## **Middleby Marshall** *Service Bulletin*

Orientation and part numbers of PS555/570/570S blower wheels and cooling fans - REVISED

# PS555/570/570S Blower Wheel Configuration

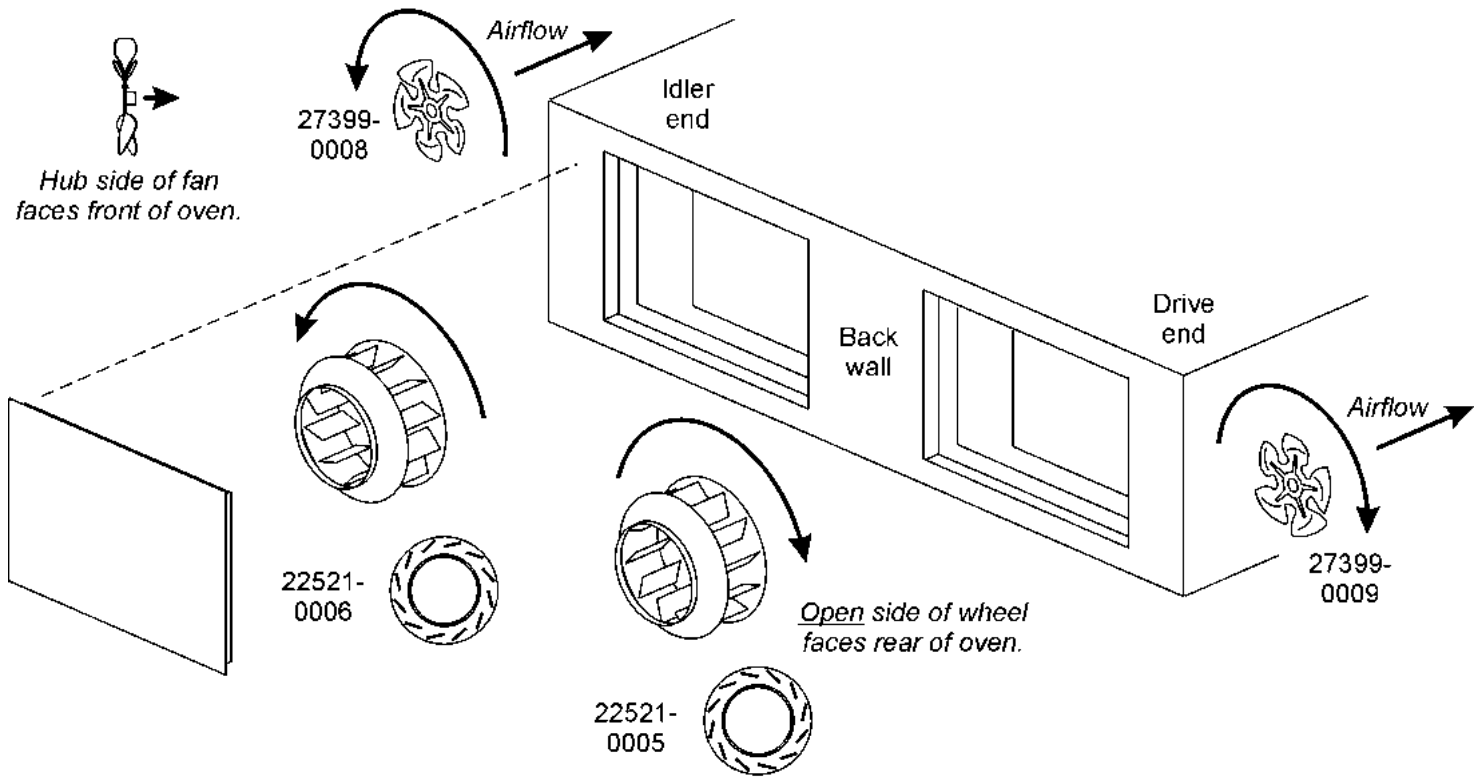
Service Bulletin MM-183, dated 4/23/01, incorrectly identified the part numbers of the blower wheels on PS570 and PS570S ovens. The illustration included with the bulletin correctly showed the fan blade orientation, and the positioning of the wheels inside the oven; however, the part numbers of the two wheels were reversed.

Also, note that the blower wheels and cooling fans for the PS555 oven are IDENTICAL to those used on current-production PS570S ovens. So, the revised illustration included with this Service Bulletin applies to the PS555 as well.

Please DESTROY the illustration that was FAXed with Service Bulletin MM-183.

Refer to the revised illustration on Page 2 of this Bulletin. File a copy of this new illustration with your PS570/570S Parts Manual and your PS555 Parts Manual. Refer to the illustration when ordering blower wheels or cooling fans for these ovens.
